PLAN COMMISSION

INTER-DEPARTMENTAL REVIEW COMMITTEE REPORT

717 E. BUTTERFIELD ROAD

PC 23-21

PRELIMINARY
ENGINEER PROJECT # 20204
PRINTED FOR PRELIMINARY
DATE: 09/12/2023
CHECKED BY: JFR
DESIGNED BY: JFR
LANDSCAPE PLAN
SHEET NUMBER
L-101

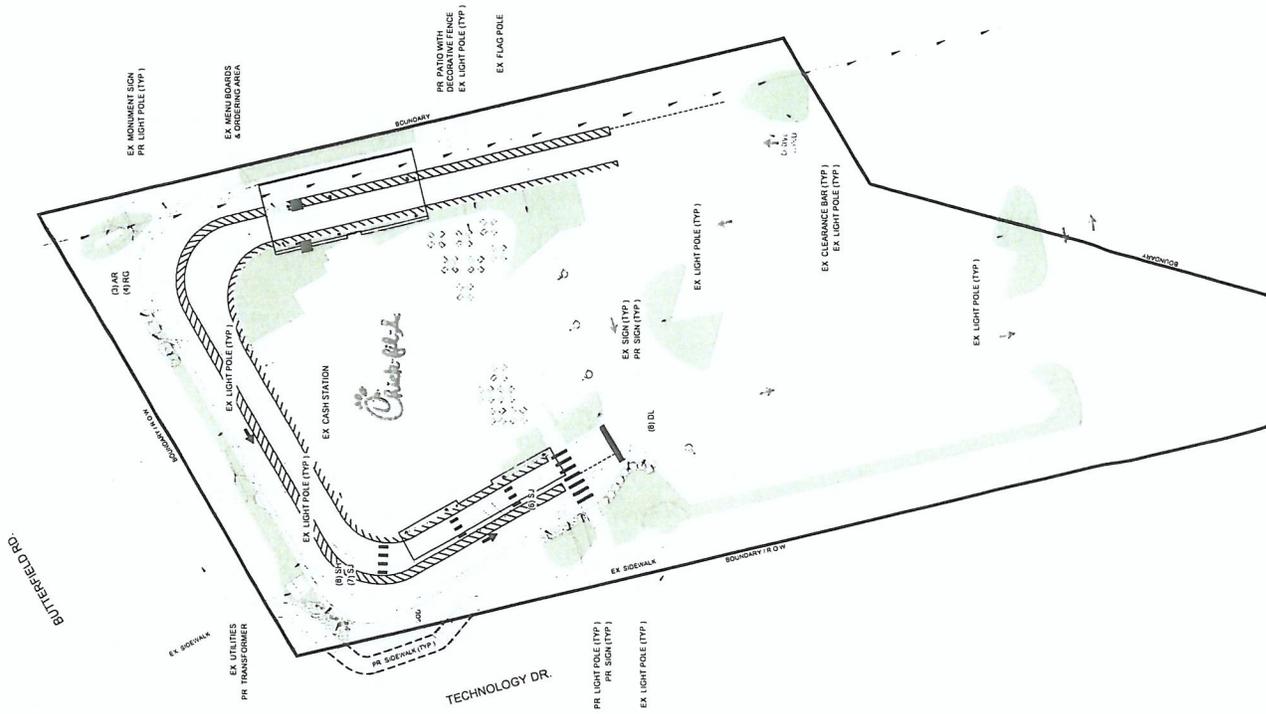
The proposed modifications will impact landscaping along the east and north property lines. The petitioner has submitted a landscape plan showing relocation and replacement of several trees in these areas. Staff finds the landscape plan consistent with the intent of the landscape plan approved with the original development (PC 11-09).

EAST ELEVATION

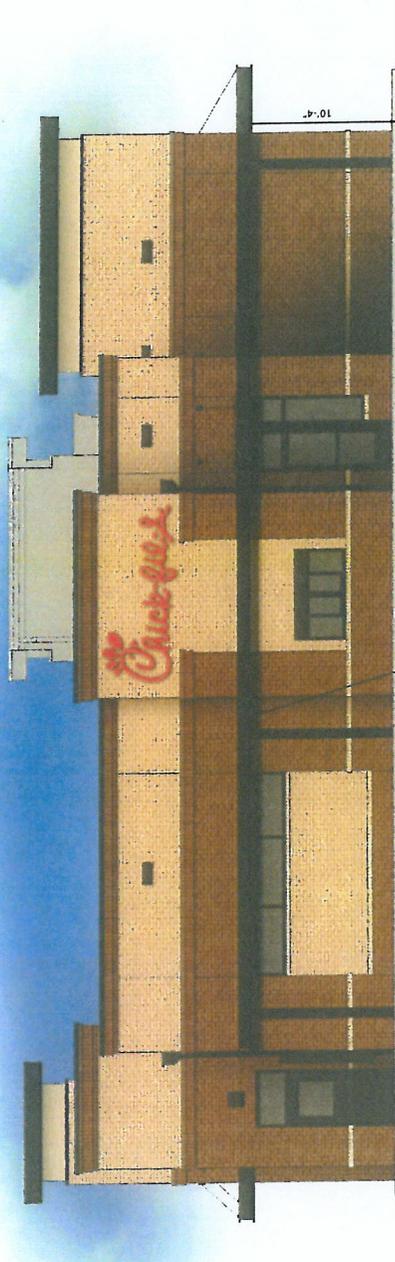
The proposed canopy on the east side of the building will have a setback of eight feet from the side property line. Village Code requires interior side yard setbacks of 10 feet in the Office District. The petitioner states the canopy is intended to provide protection from the elements for Chick-fil-A employees and customers. The reduced side yard setback will permit the canopy to fully cover both drive-through lanes.

Staff does not anticipate any adverse impacts on nearby properties resulting from the proposed canopy. The open nature of the canopy structure will reduce its visual impact, and the adjacent property has a landscape buffer along the shared property line. The canopy has been designed to complement the architecture of the existing restaurant. Staff supports the requested deviation.
